Re: Sunport Apartments- Phase 2
2920 Mulberry St. SE
Traffic Circulation Layout
Architect's Stamp 02-28-23 (M15-D036)

SUNPORT APARTMENTS-PHASE 2
SITE PLAN
2920 MULBERRY ST. SE
ALBUQUERQUE, NM.
PROJECT # 2311

REVISION	DATE
RBA ARCHITECTURE, PC ARCHITECTURE PLANNING DESIGN 1000 Ave. SE Albuquerque, NM 87102 www.rba.com	
DATE	2/28/2023
SHEET NUMBER	AS-1.00

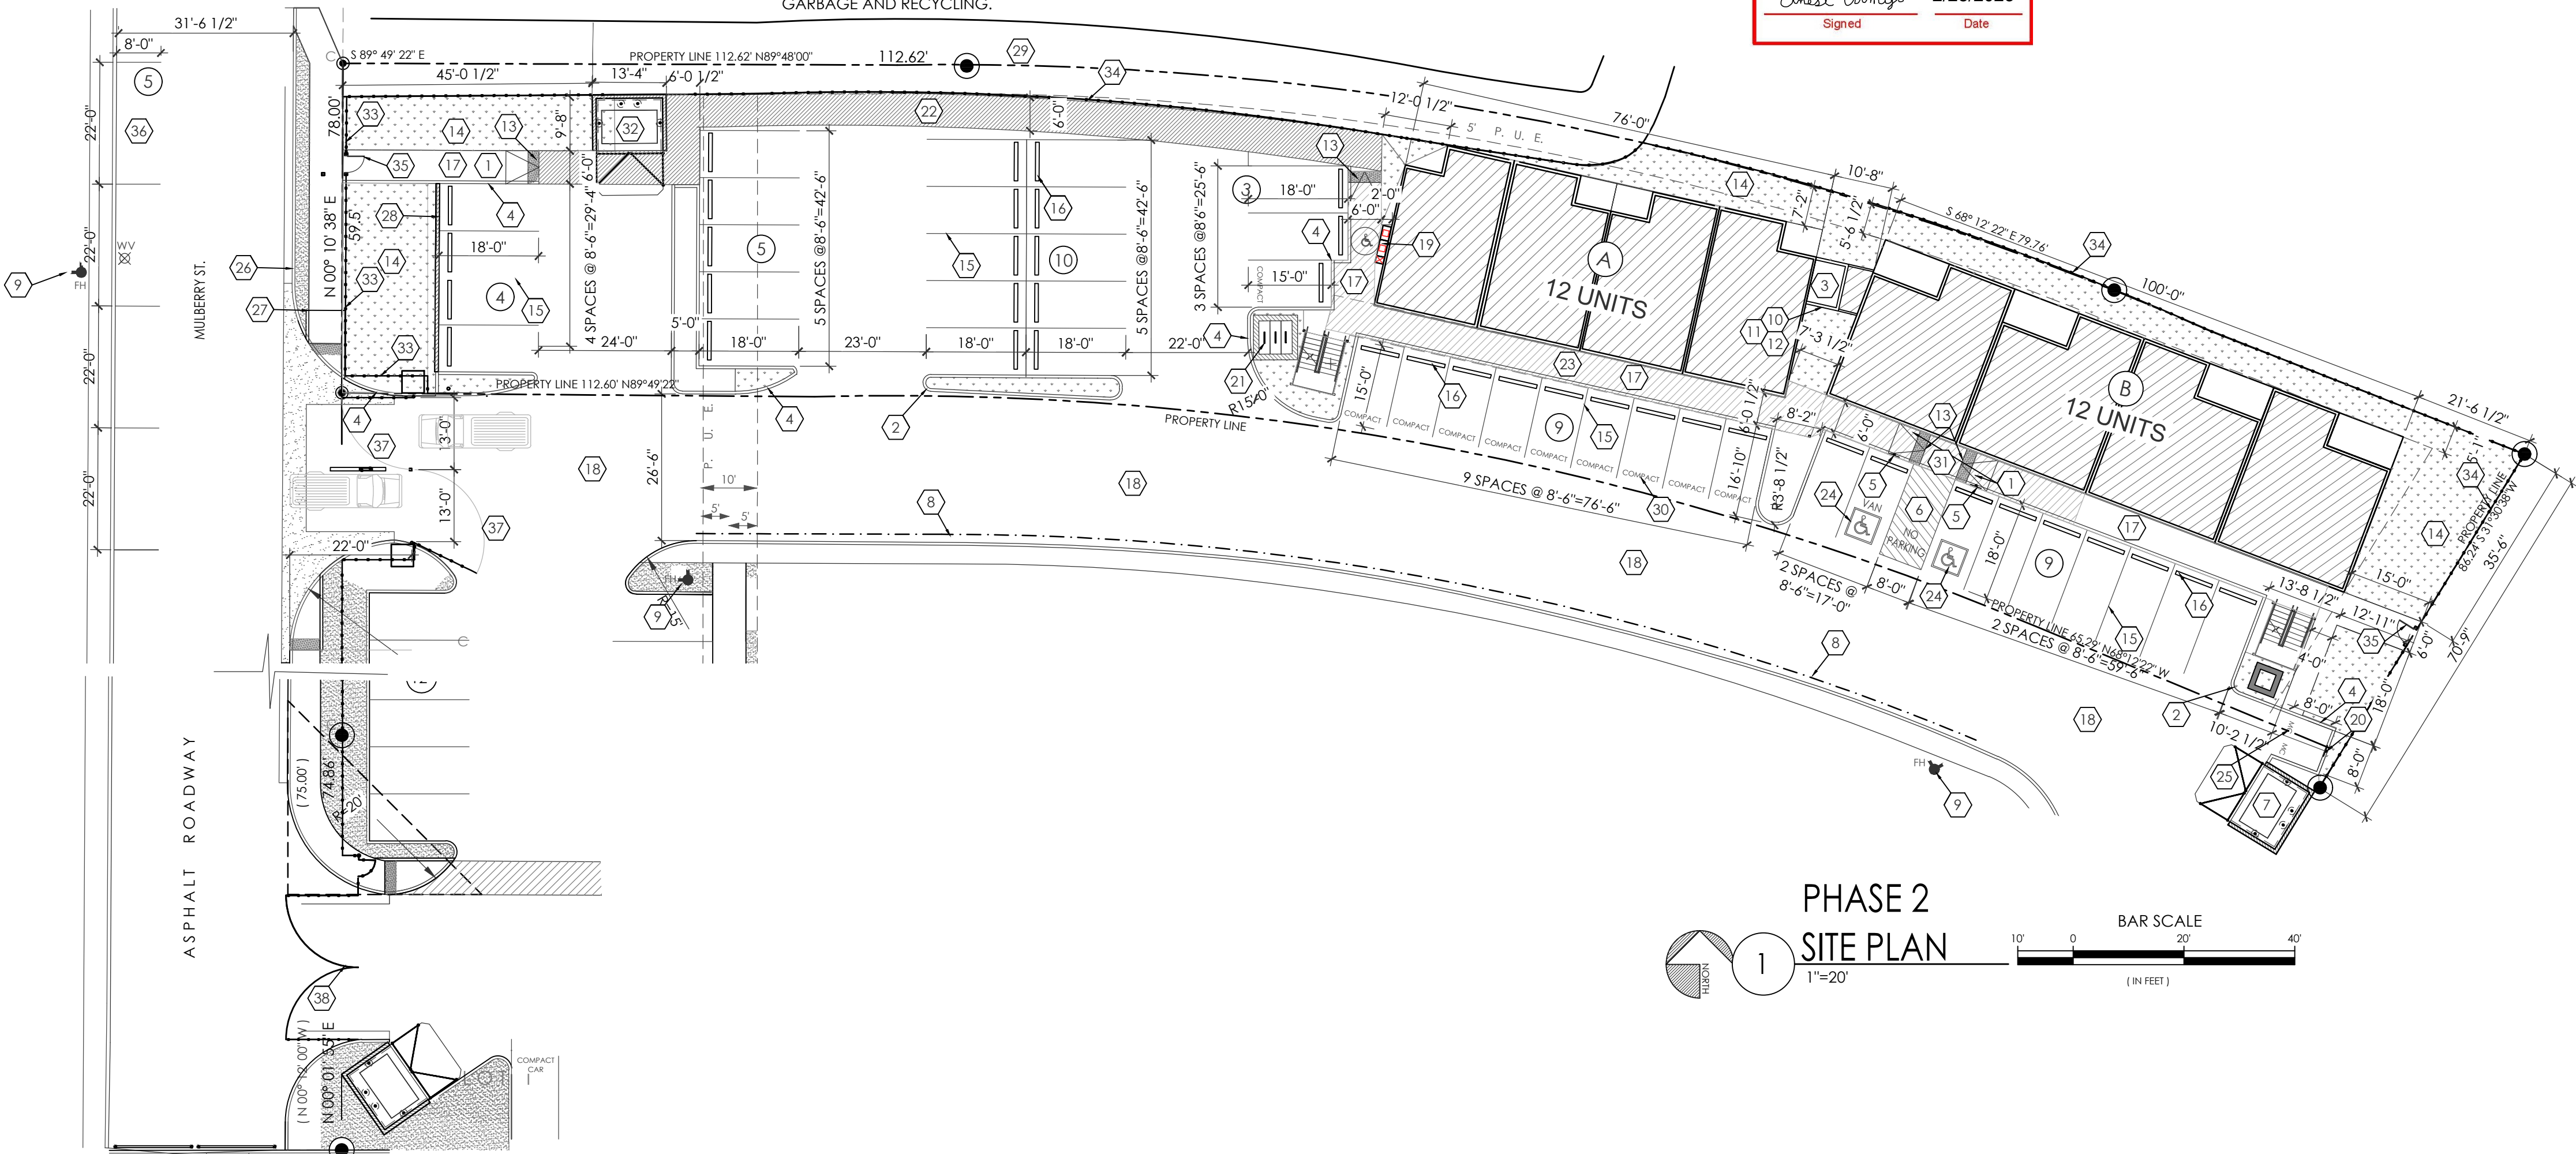
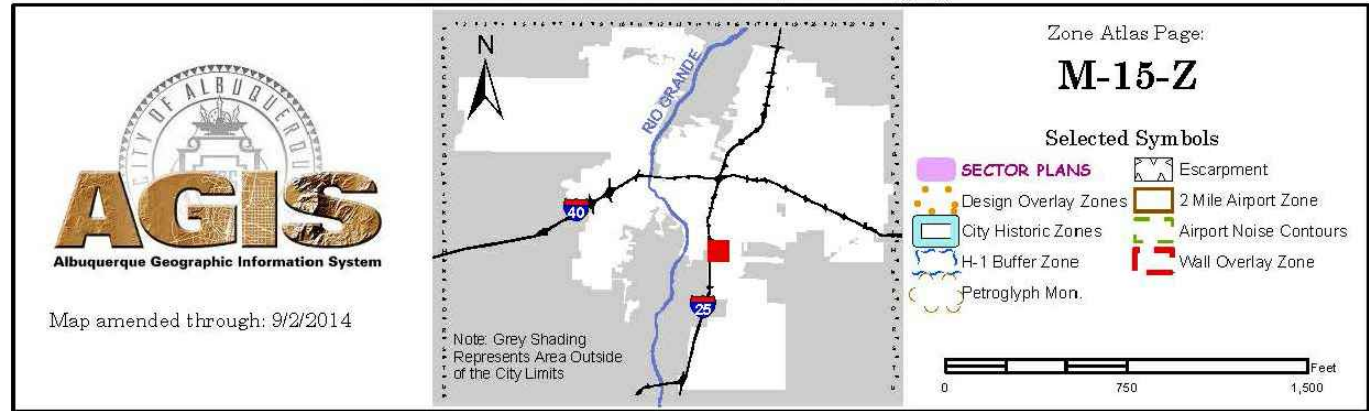
The TCL submittal received 01-24-2023 is approved for Building Permit by Transportation. A copy of the stamped and signed plan will be needed for each of the building permit plans. Please keep the original to be used for certification of the site for final C.O. for Transportation.
